September 20th, 2019

Re: Agnico Eagle's response to Meadowbank (2AM-MEA1526) Ground Water Monitoring Plan, Meadowbank Interim Closure and Reclamation Plan, Pore Water Quality Monitoring Program and Waste Rock-Tailings Management Plan comments

Figure 1: Location of the north-south cross-section with chloride plumes at t=20,000 years

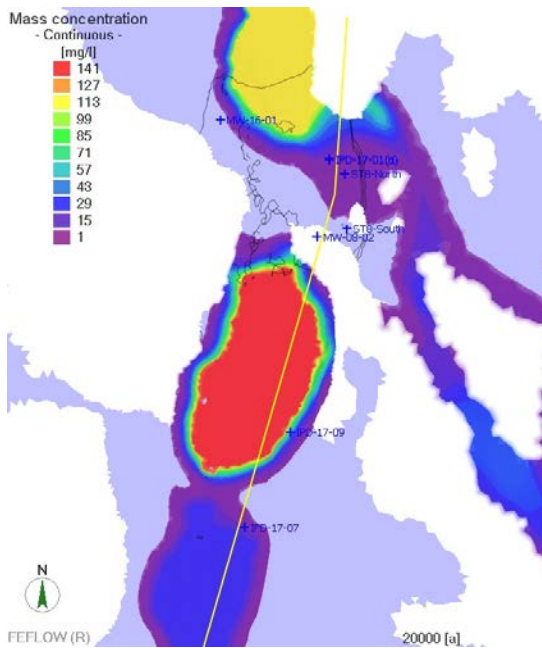
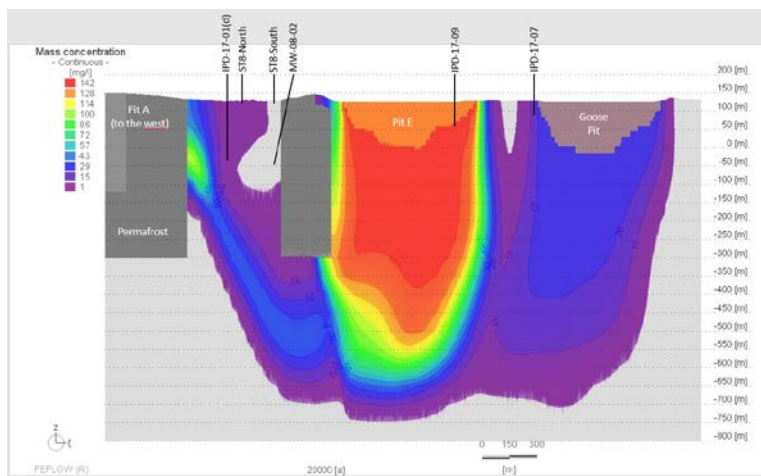
Recommendation 6: CIRNAC requests clarification on where the 3D model breakthrough curves predicted the highest chloride concentrations, and if the existing monitoring wells network intersects each of these predicted highest chloride concentration areas

In December 2018, the 3D hydrogeological model was updated (version 4) as per NRCan recommendations, and with their satisfaction. Even if it is challenging to have a clear 2D extraction of this modelling results, figures 1 and 2 below were produced to show predicted chloride plumes 20,000 years after pit flooding. Existing monitoring wells are also shown in the map and cross-section.

At Goose Pit, the MW-IPD-17-07 is aligned in the groundwater and plume pathway and screen depth allows to track the simulated chloride concentrations. At Pit E, the MW-IPD-17-09 is also aligned in plume pathway and its screen depth is close from the pit rim, allowing to intercept the simulated chloride plume.

At Pit A location, MW-IPD-17-01 is not perfectly aligned with predicted chloride plume (figure 1 and figure 2). However, as the location of the predicted plume is in the current permafrost area, it would not make sense to install any monitoring well in this area at this time. Monitoring of ground temperature during operation is required before installing any new well.
